39500 ORCHARD HILLS PLACE JF19-04

39500 ORCHARD HILLS PLACE JF19-04 – SECTION 9 WAIVER

FAÇADE REVIEW

Re: **FACADE ORDINANCE REVIEW**
Orchard Hills Place, JF19-04
 Façade Region: 1, Zoning District:

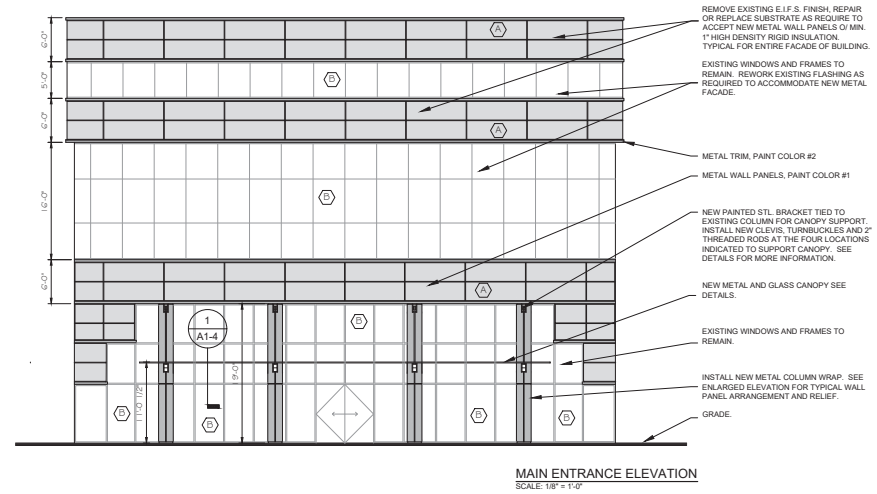
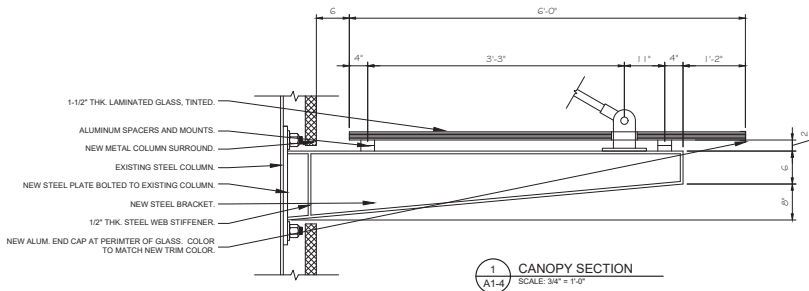
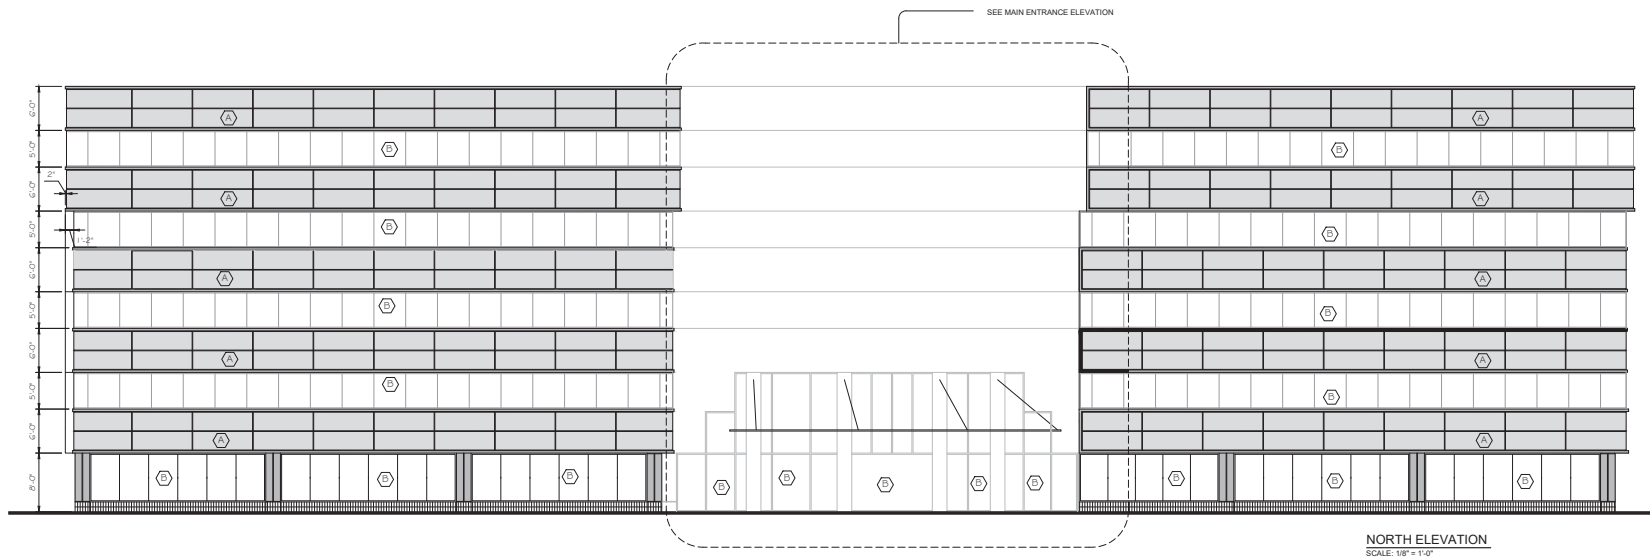
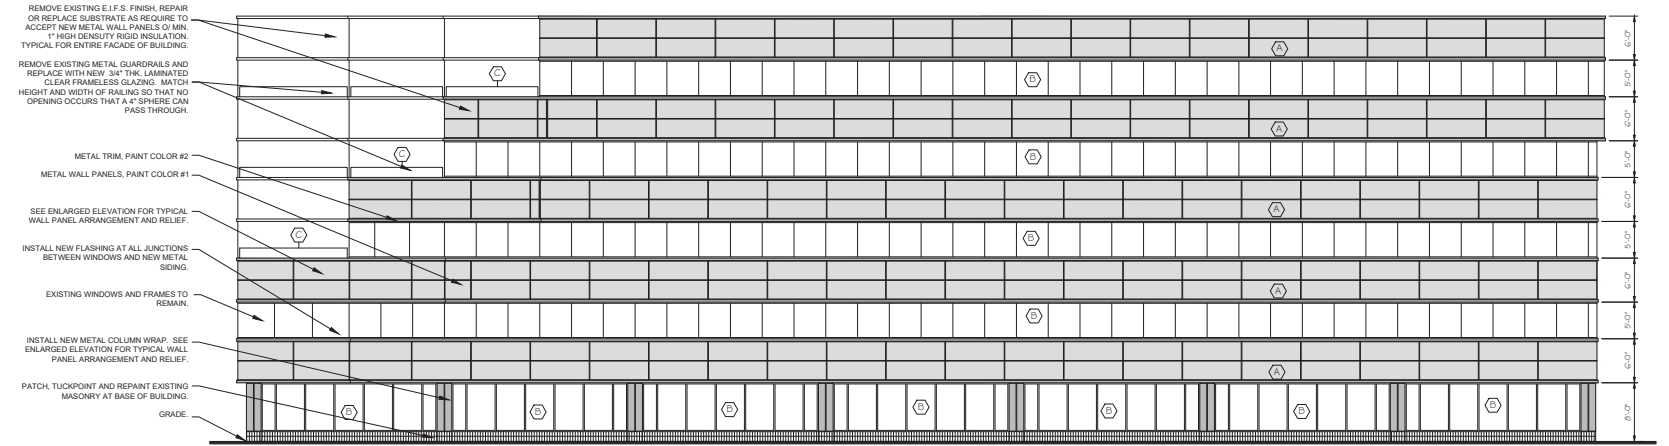
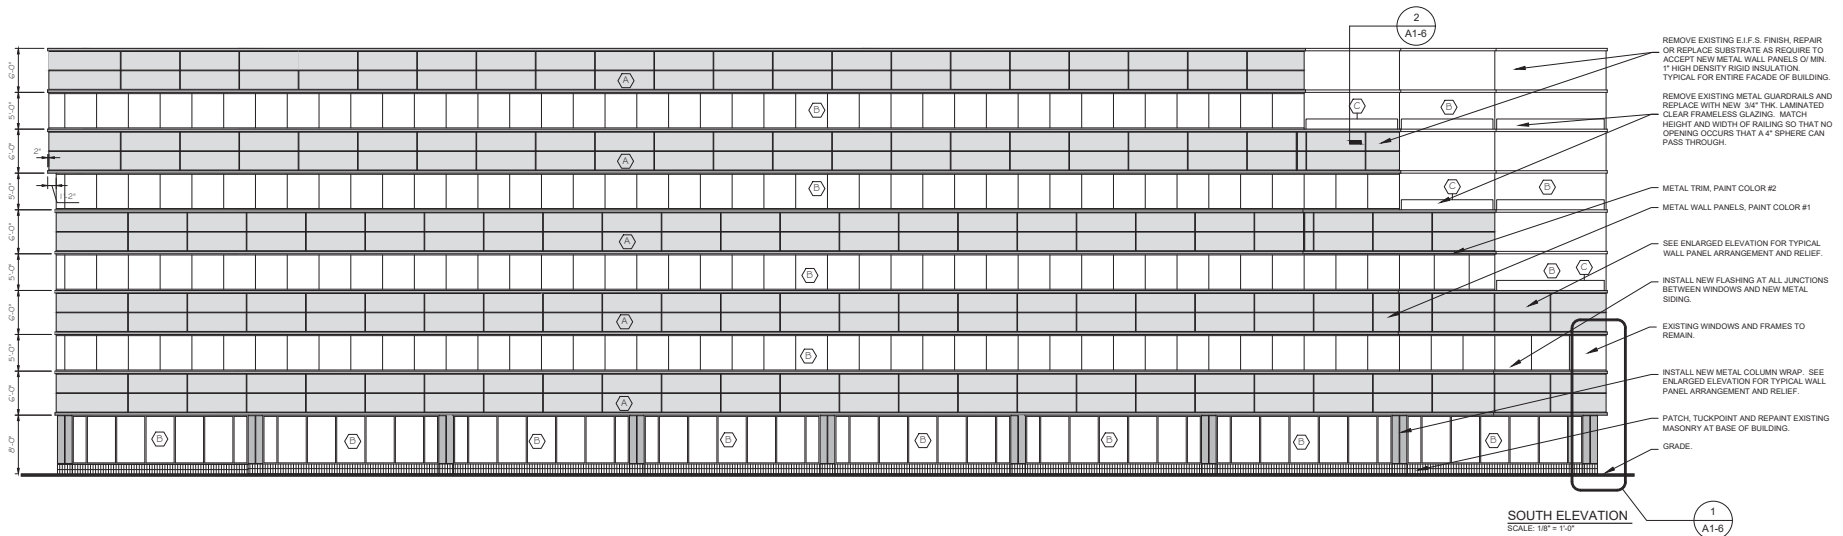
Front	Rear	Left Side	Right Side	Façade Ordinance Section 5.15 Maximum
Brick	7%	7%	7%	7%	100% (30% Minimum)
Flat Metal Panels (CEI R4000, or similar)	93%	93%	93%	93%	50%

This project is considered a Façade Alteration as described in Section 5.15.6 of the Façade Ordinance. The applicant is proposing to replace the existing primary façade material (EIFS) with a Flat Metal Panel system. Section 5.15.6 states that when new materials are proposed for an existing building façade, the entire façade shall be brought into compliance with the Façade Chart. As shown above the minimum percentage of Brick is not provided and the percentage of Flat Metal Panels exceeds the maximum amount allowed by a significant percentage. Therefore, a Section 9 Waiver would be required for these deviations.

This building was originally constructed in 1986, prior to adoption of the Façade Ordinance. In this case adding brick to the extent required by the Façade Ordinance would represent extreme practical difficulty and would not significantly enhance the buildings appearance as compared to the proposed materials (flat metal panels). The type of Flat Metal Panels proposed (CEI R4000) is in fact a high-quality aluminum rainscreen system using metal composite panels. This material offers significant benefits as competed to the original EIFS material and other flat metal panel systems.

The improvements to the building also include the addition of a new laminated glass entrance canopy, wrapping exterior columns with the metal panel system and replacing the existing tubular steel balcony guard rails with glass guard rails.

Recommendation – We believe that the proposed alteration will represent a significant improvement to the overall aesthetic value of the building. For the reasons stated above, it is our recommendation that this application is consistent with the intent and purpose of the Façade Ordinance and that a Section 9 Waiver be granted for the underage of Brick and overage of Flat Metal Panels. The applicant should provide color samples of all façade materials not less than 5 days prior to the Planning Commission meeting.
